RE: **Addendum No. 1**, to Design RFP934600-01, DSM 5JD Administration Office Roof Replacement

DAS Project 9346.00 DSM 5JD Administrative Office Roof Replacement Design RFP934600-01

- 1) Google Earth View (1 page)

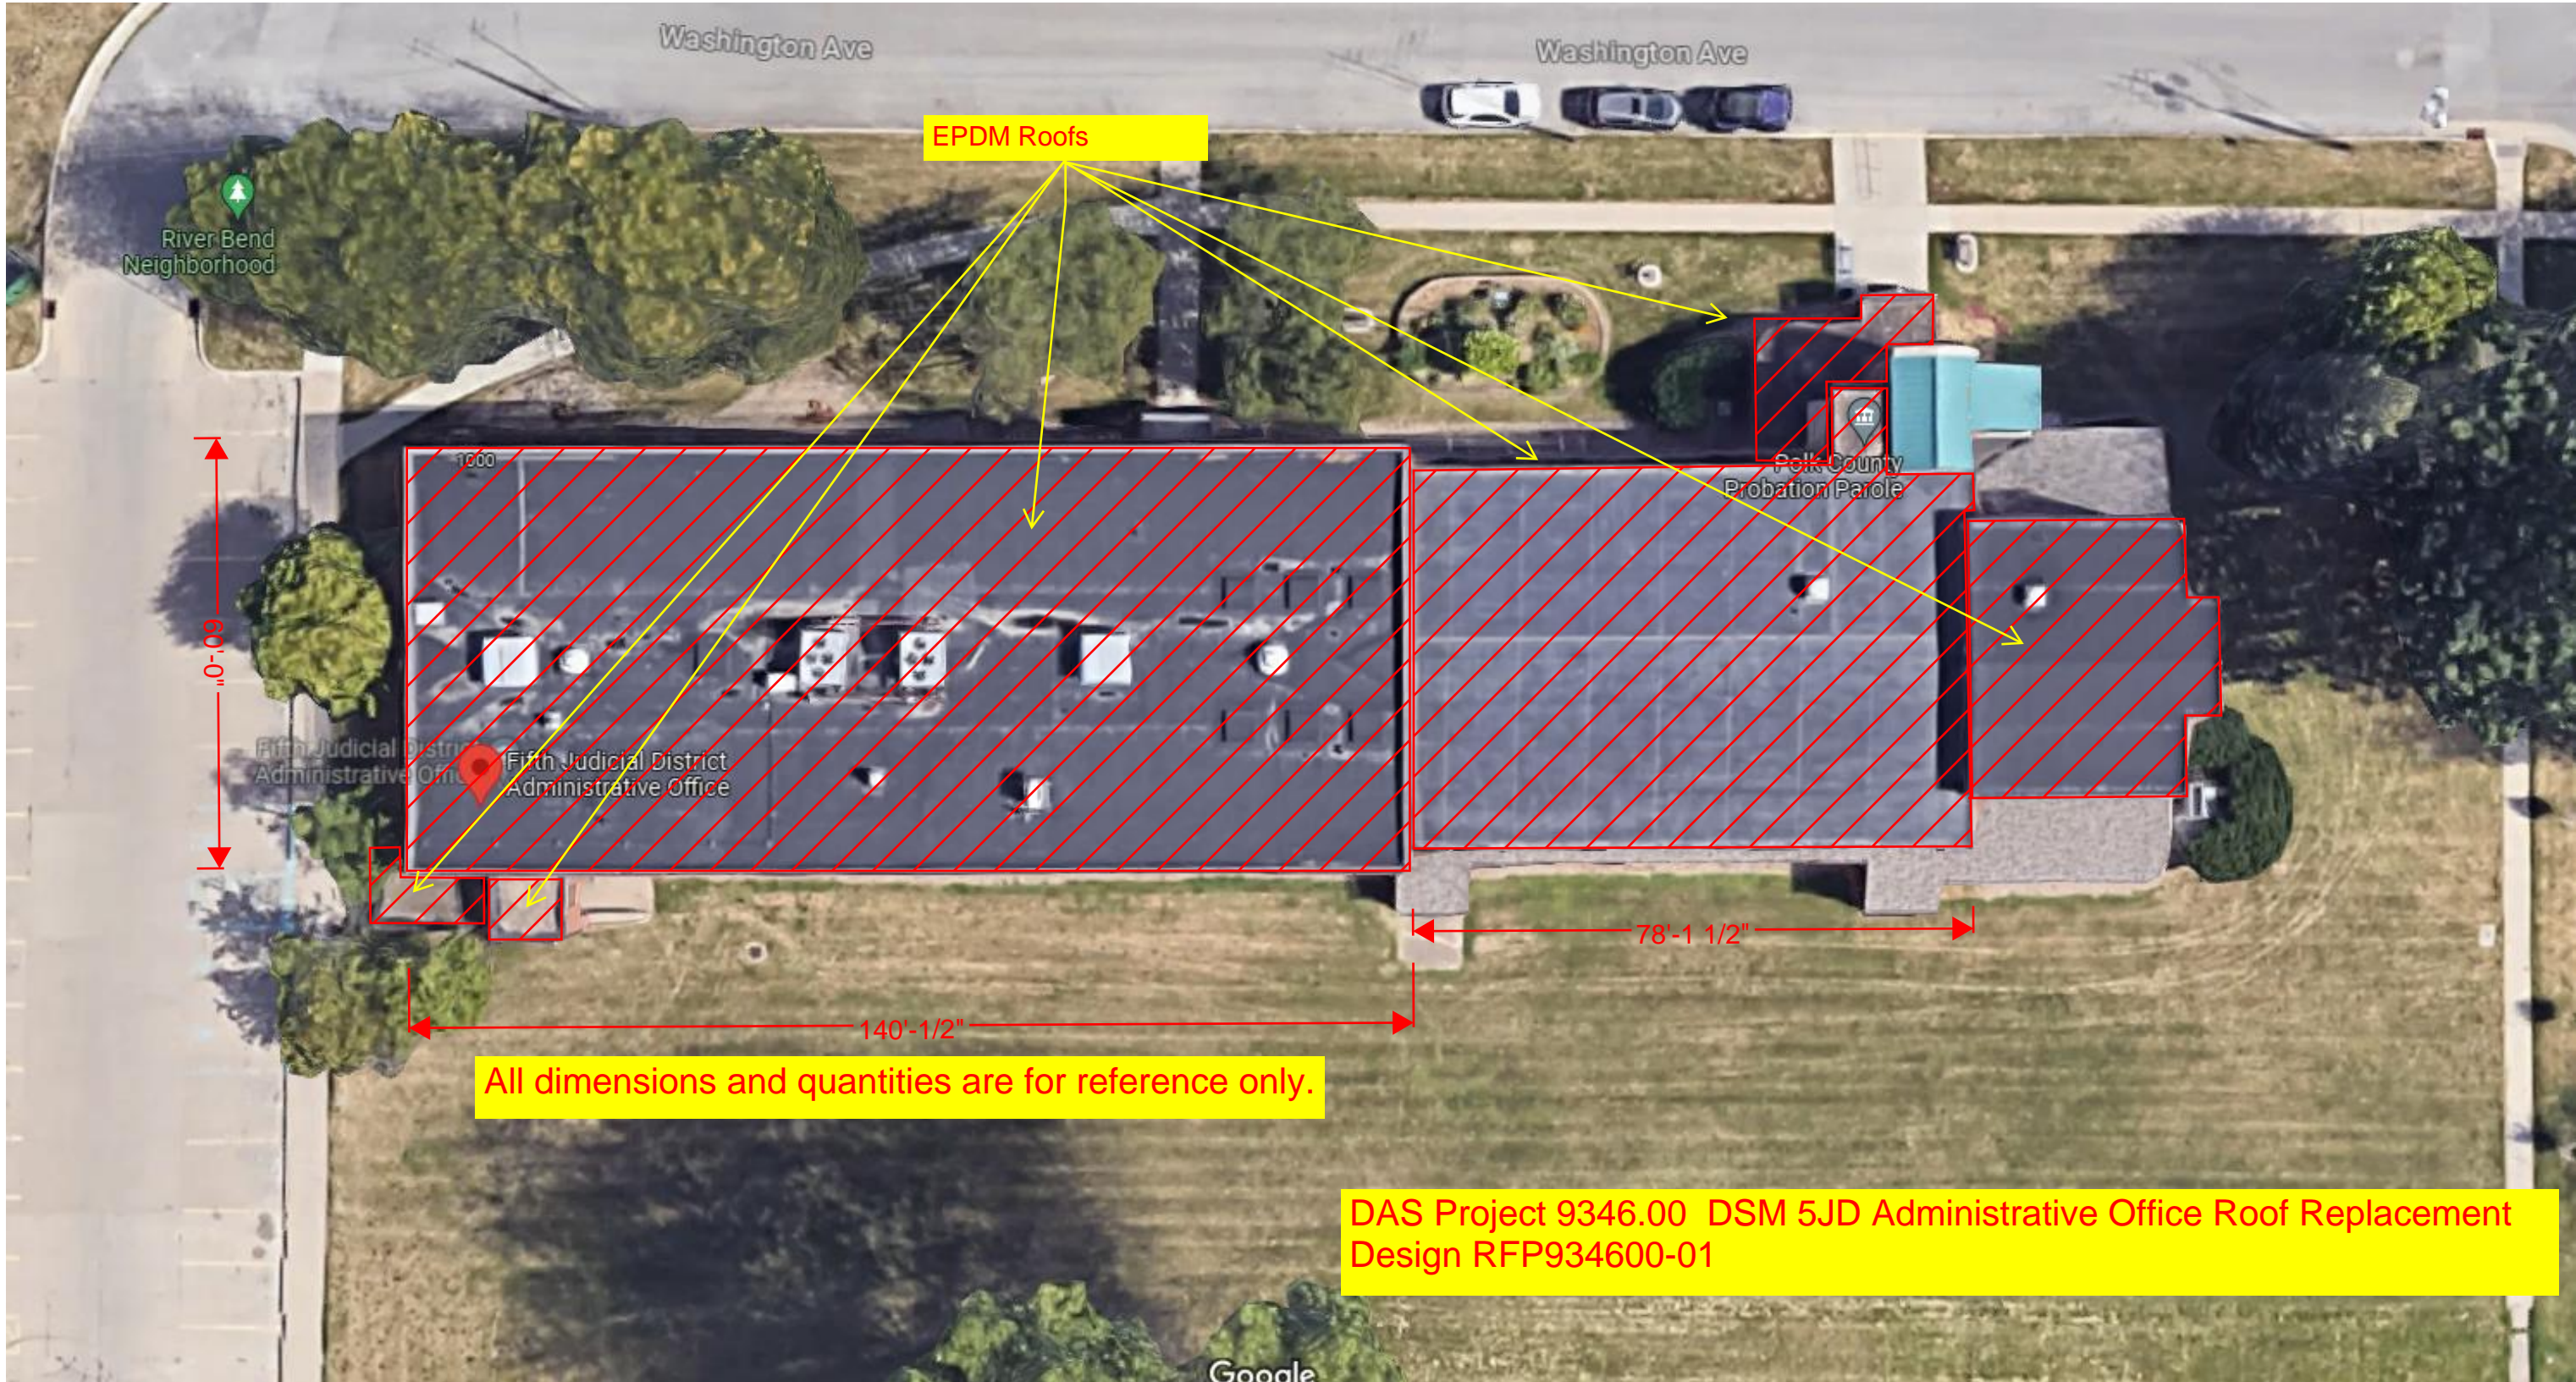
- 1) Has an initial budget been established? **A> Yes, an initial budget for construction is \$418,000. Soft costs for the project are not included in this number.**
- 2) RFP stated "Existing CAD/PDF drawings will NOT be provided to the successful design firm. Accuracy of drawings shall be verified by the design firm(?)." Should we assume there are no existing drawings-correct? **Yes, as noted in the RFP there are no existing CAD or PDF files available for this project.**
- 3) Are the lower ballasted roofs included in the project? **A> Yes, all EPDM roofs (ballasted and non-ballasted) are included in the scope of this project except for one small entry roof on the NW side of the building. See attached google image of the building for reference of areas. Any existing shingled or metal roofs are not included in the scope.**

- 1) See attached Google Earth image for areas of roofing.
